Project No. 20141048

TECHNICAL MEMORANDUM

**UNIT 3 IMPOUNDMENTS ALTERNATE SOURCE DEMONSTRATION RESPONSE
GRAND HAVEN BOARD OF LIGHT AND POWER - JB SIMS POWER GENERATING STATION**

Figure 1: Effect of Compaction on Soil Structure

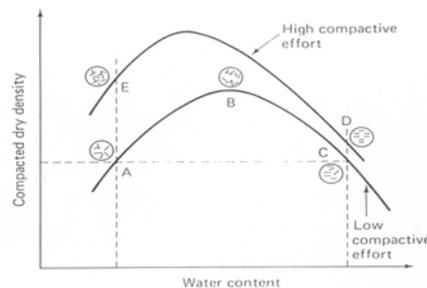
- 1) GHBLP observed that during closure, the unit appeared to be visually intact and therefore GHBLP has claimed the unit has not leaked during its lifetime. GHBLP appears to discount natural migration of liquid through an engineered clay barrier. EGLE used available information to calculate an**

estimated time of breakthrough. EGLE considered the site conditions and assumed the liner was a monolithic intact liner as a best-case scenario. Even with a best-case scenario, EGLE calculated that natural breakthrough of the clay liner could be as soon as 15-25 years. The units have been active since the early 80s. EGLE therefore believes it is not appropriate to assume that the unit has not leaked during its lifetime based on visual inspection alone.

Golder has provided multiple lines of evidence that the clay liner for the former Unit 3 impoundment remained intact. EGLE provided a time of travel assuming a breakthrough of the clay liner at 15-25 years. EGLE's assumptions do not take several factors into consideration including:

- The clay liner was properly engineered and constructed to a minimum of 3-feet thick using compaction methods that promote the clay particles to align perpendicular to the flow path, decreasing the liner's permeability further. See below for a Figure from Lambe, 1985 that shows the relation between compaction effort and relative density and moisture content.
